# AGENDA

## April 18, 2024, Standards Committee Meeting

Standard Drawing:  
E 609-RCBA-04

REINFORCED CONCRETE BRIDGE APPROACH SECTION,  
PAVEMENT LEDGE, AND BAR BENDING DETAILS

E 609-RCBA-04 REINFORCED CONCRETE BRIDGE APPROACH SECTION, PAVEMENT LEDGE, AND BAR BENDING DETAILS (with shown markups)

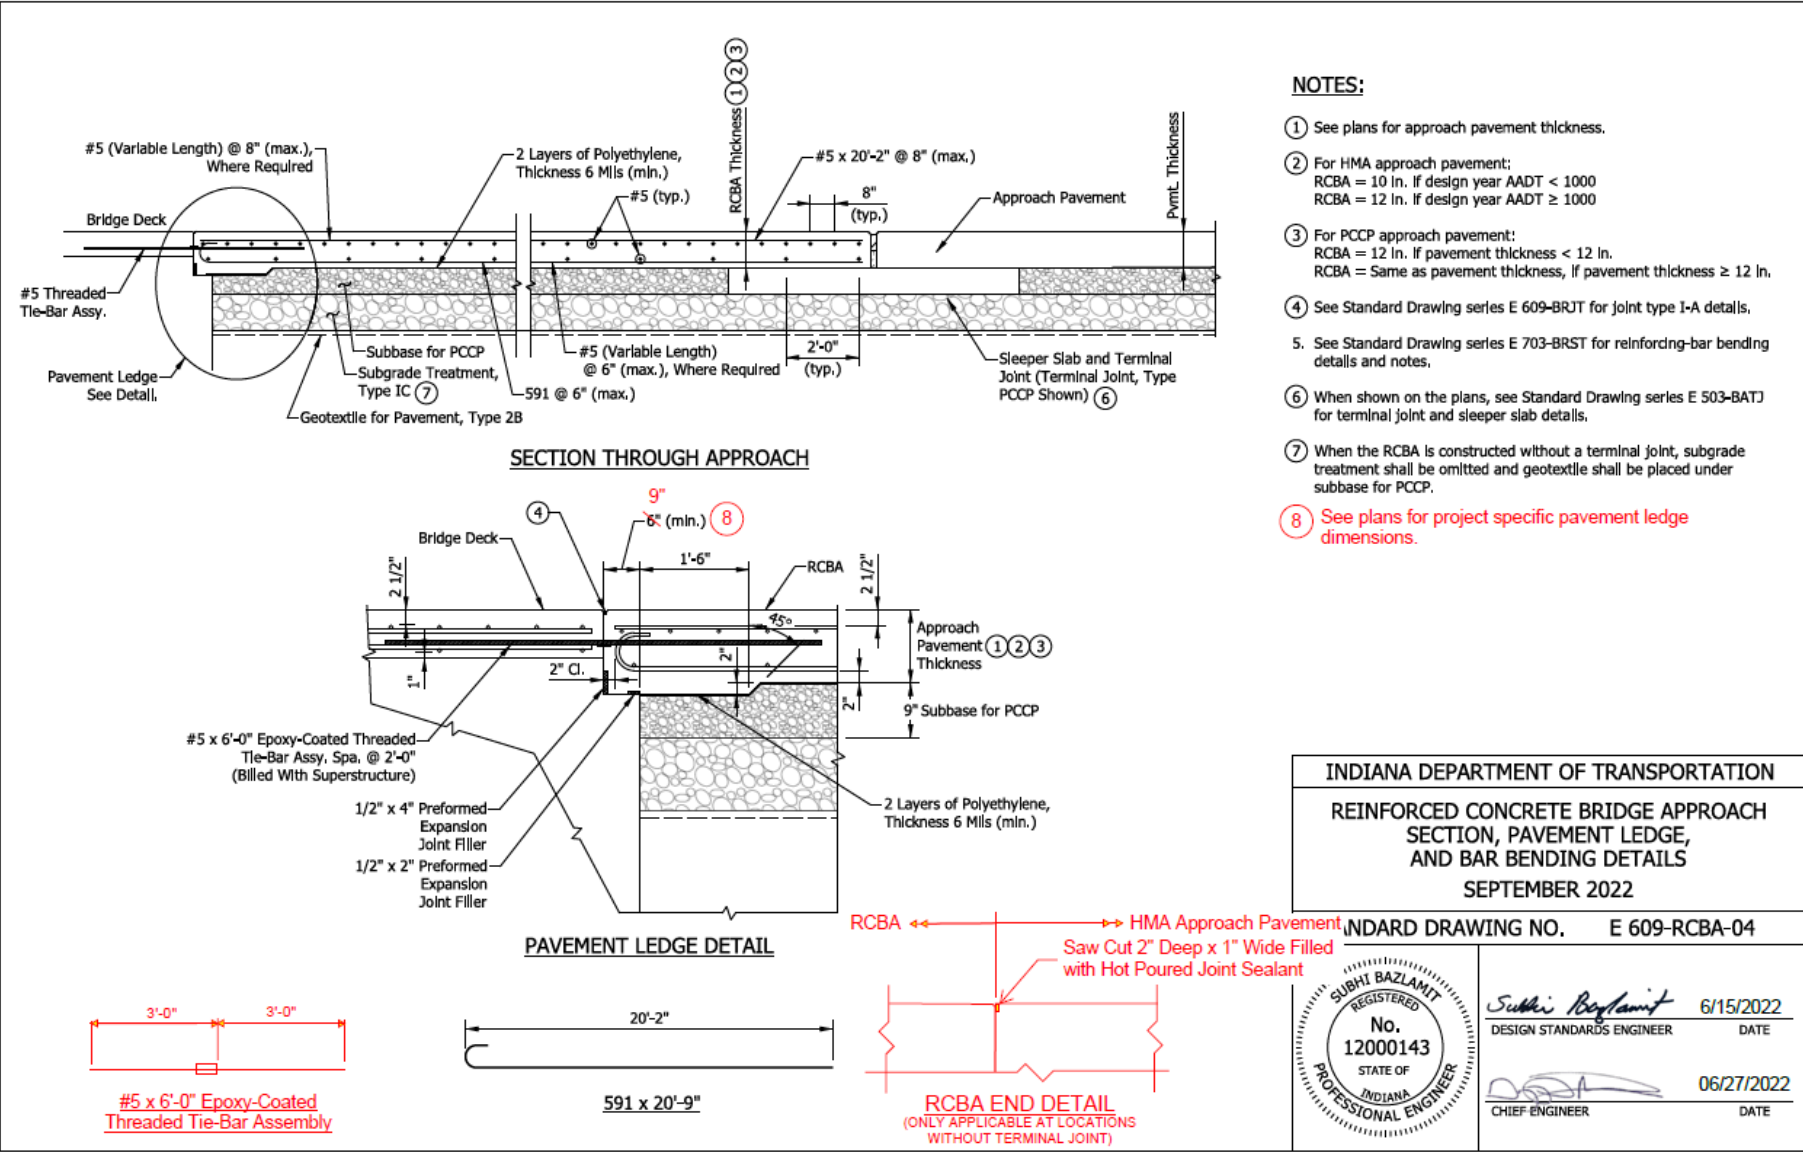
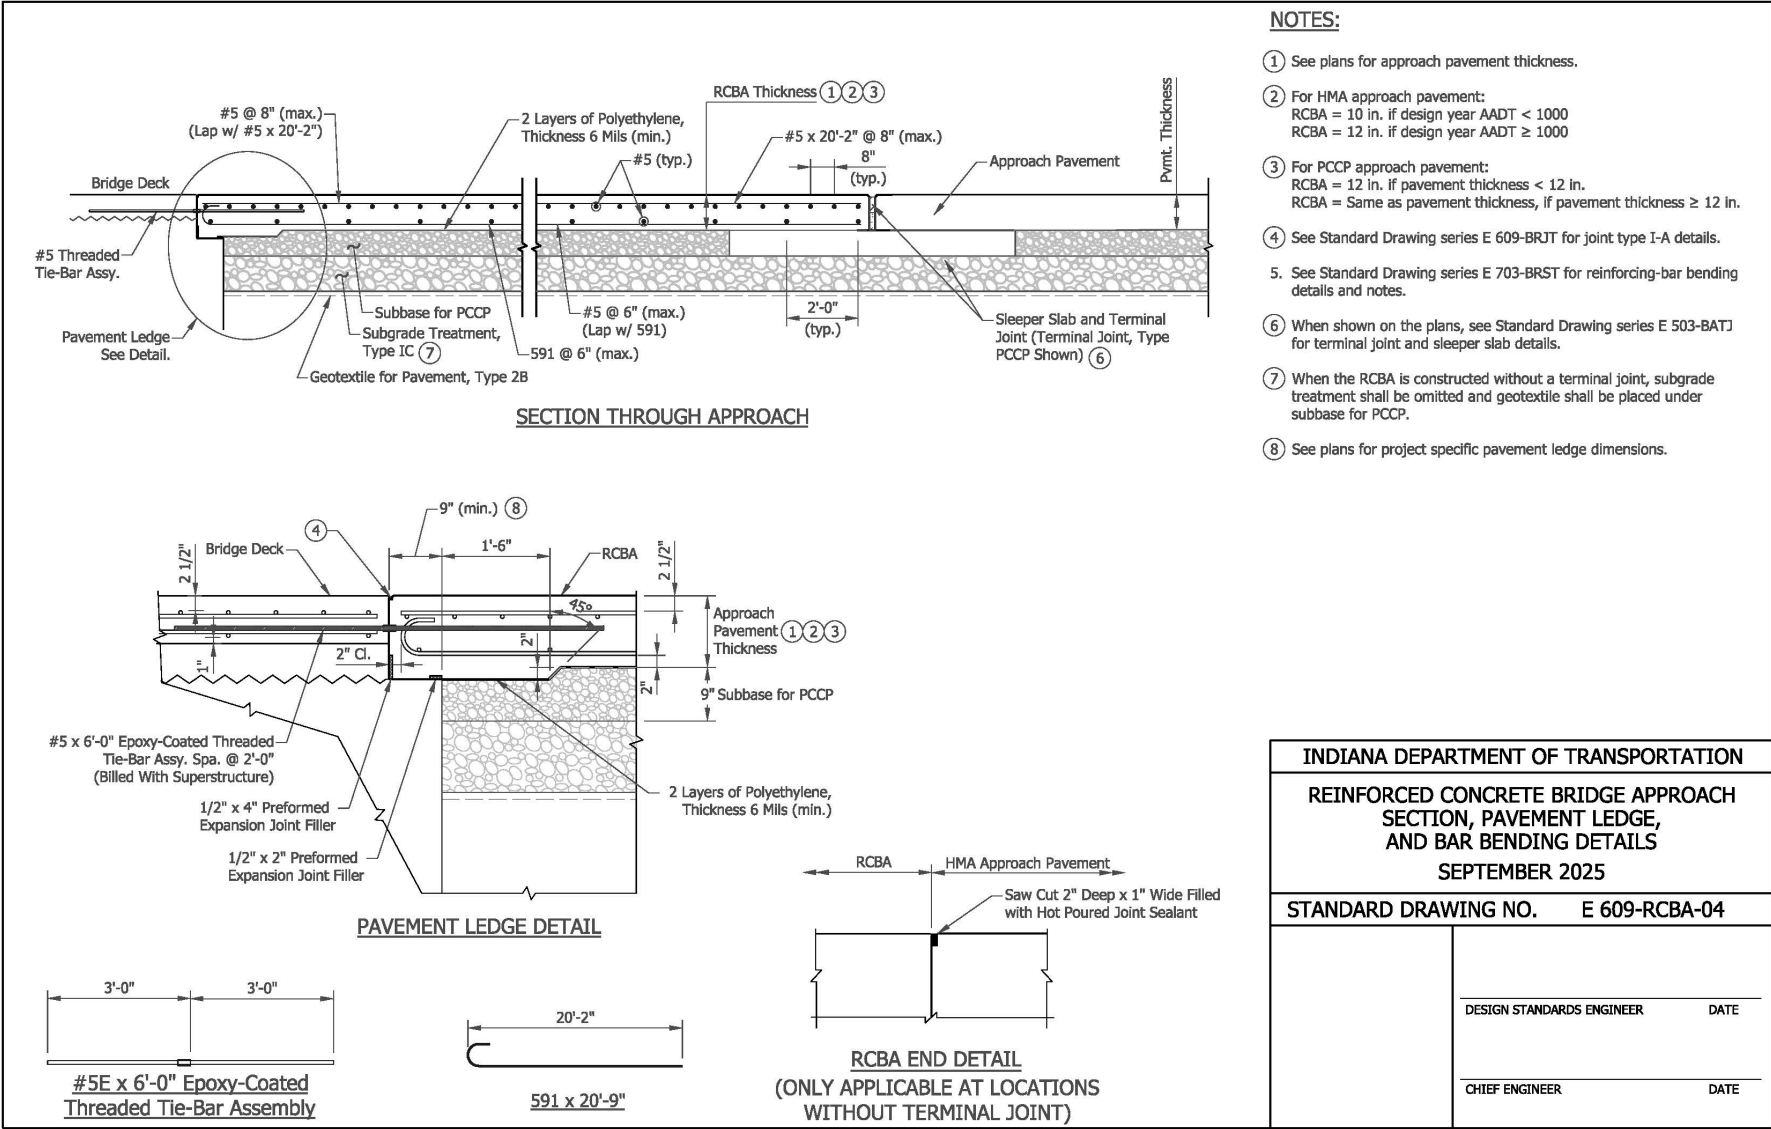
PROBLEM(S) ENCOUNTERED: The current standard pavement ledge width of 6” can create vulnerabilities to future settlement of the RCBA relative to the bridge deck. The concrete-to-concrete bearing width is only 3 ½” after subtracting the widths of the PEJF material, so even a relatively small amount of deterioration or poor concrete consolidation can result in insufficient bearing capacity, which can lead to settlement. It has also been observed that the interface between the end of the RCBA and adjoining HMA pavement, when no terminal joint is required, can develop a slight separation that can allow water infiltration.

PROPOSED SOLUTION: Increase the standard pavement ledge width from 6” to 9” and add a detail to seal the interface between the end of the RCBA and adjoining HMA pavement when no terminal joint is required.

E 609-RCBA-04 REINFORCED CONCRETE BRIDGE APPROACH SECTION, PAVEMENT LEDGE, AND BAR BENDING DETAILS (proposed draft)
